Z-36 (2013)
SARAH OAKS
1157 & 1182 ROSWELL ROAD

PETITION NO: Z-36

ZONING COMMENTS:

DATE	
REVISION	
SCALE	AS SHOWN
SHEET	1-Z

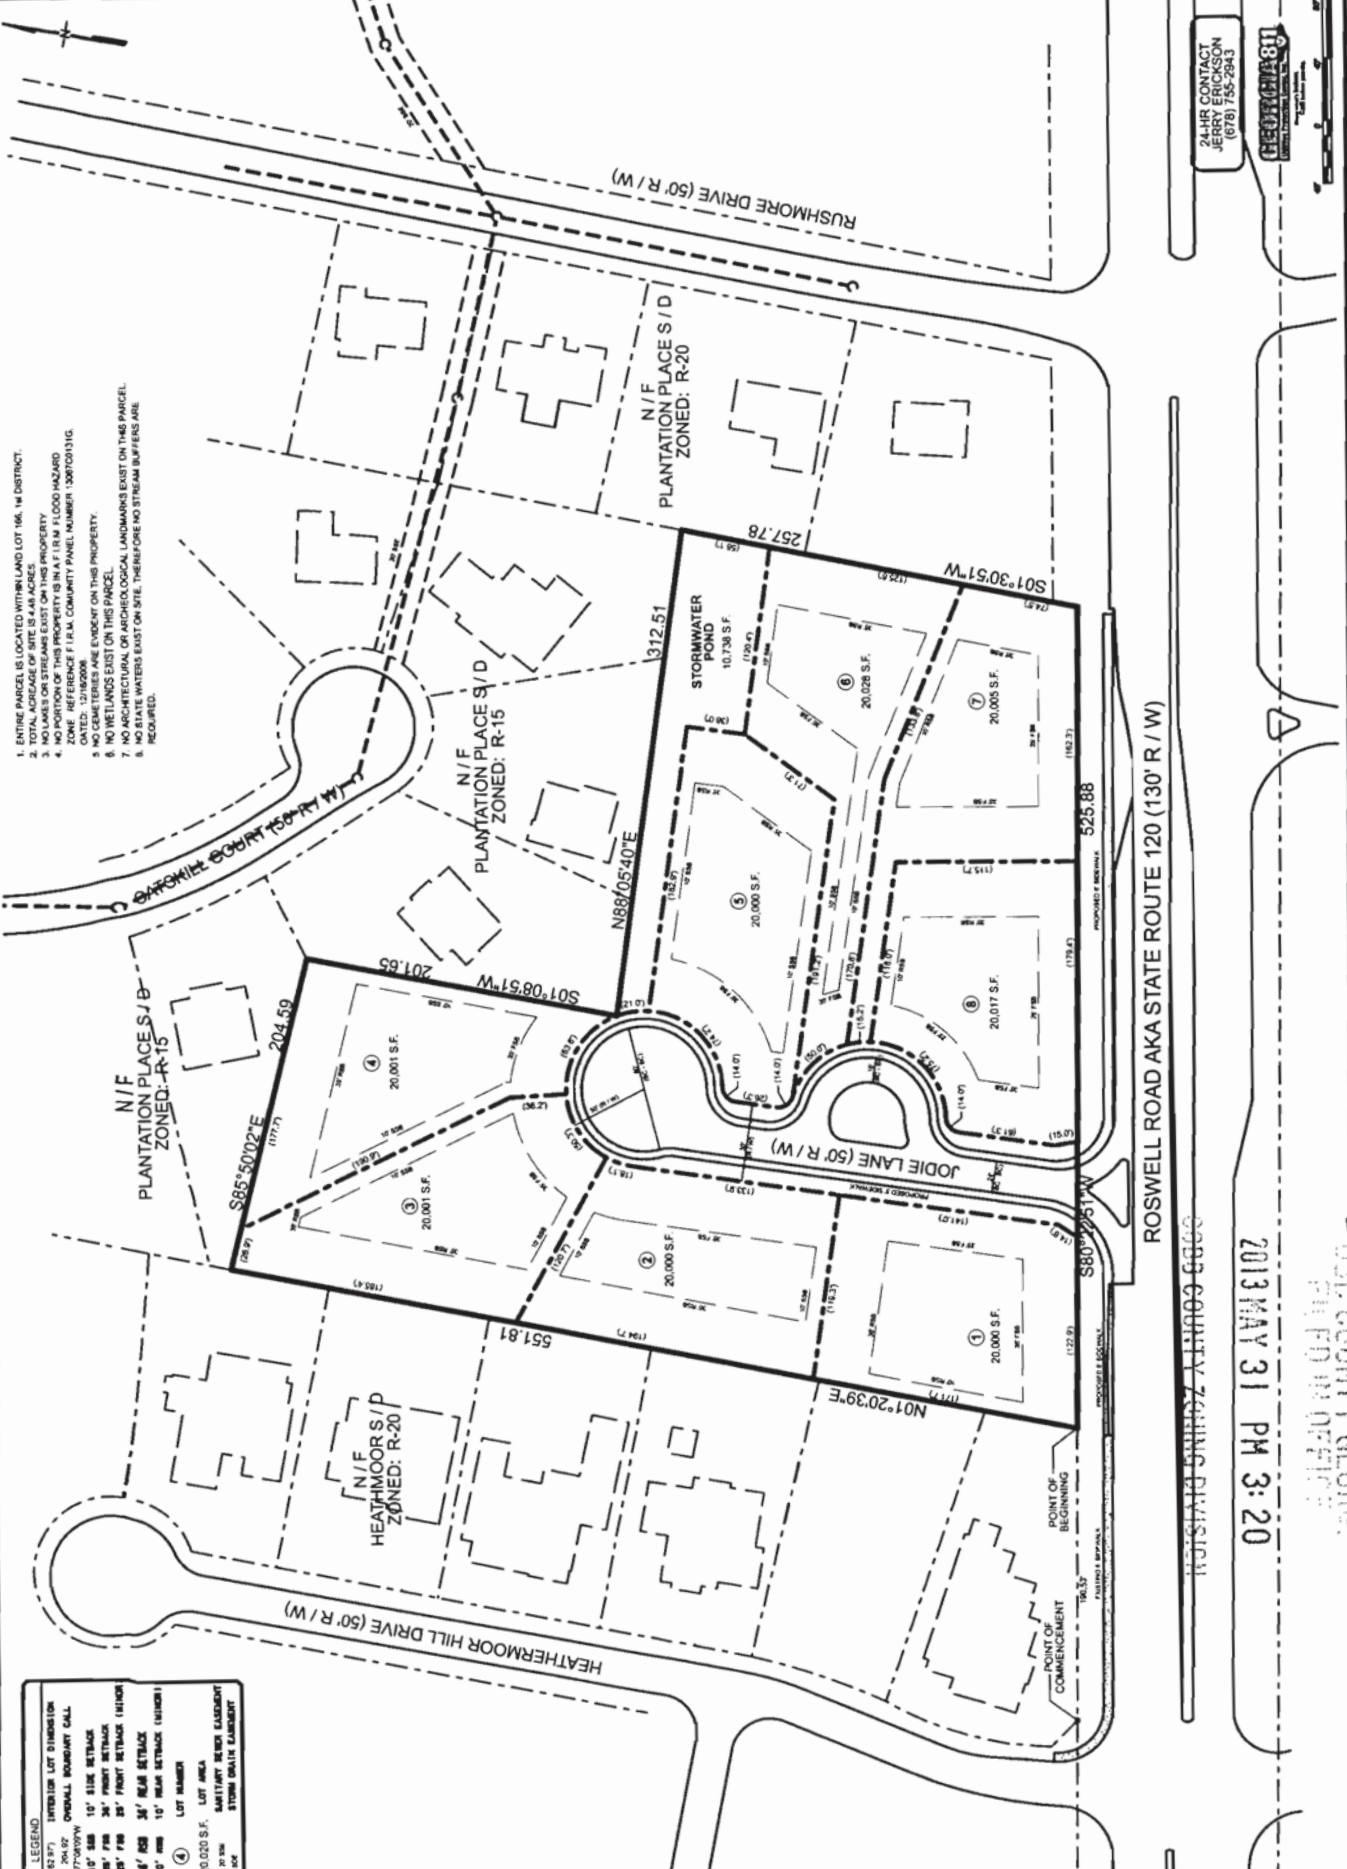
1. This site is located just north of Roswell Road and is bounded on the north and east by Plantation Place Subdivision and on the west by Heathermoor Subdivision. Slopes on the site are relatively mild averaging approximately 10%. The majority of the site (2/3) drains to the east into the Plantation Place Subdivision. The remaining third drains to the Roswell Road R/W.

2. Adequate drainage swales and easements will need to be provided along the eastern property lines of lots 4, 6 & 7 to direct site runoff to the proposed detention pond.

3. The proposed stormwater management facility is located at the low point of the site at the northeast corner. The 20-foot access to the pond must be cleared to allow adequate maintenance access to the pond. Any screening that might be requested would need to be outside this access pathway.

4. It appears that the lowest floor of the next downstream house (#2255 Rushmore Dr) may be located below the low point of Rushmore Drive. This must be verified at Plan Review and may require additional detention be provided so that the increase in runoff volume does not have an adverse impact on this structure.

Recommend curb, gutter, and wide sidewalk along the Roswell Road frontage.

Recommend curb and gutter along both sides and sidewalk along one side of proposed development roadway.

Recommend removing and closing driveway apron along Roswell Road frontage that development renders unnecessary.

Recommend removing landscape area from the center of the development roadway.

- Revised site plan received by the Zoning Division on May 31, 2013, with the District Commissioner approving minor modifications;
- Fire Department comments and recommendations;
- Water and Sewer comments and recommendations;
- Stormwater Management Division comments and recommendations; and
- DOT comments and recommendations.
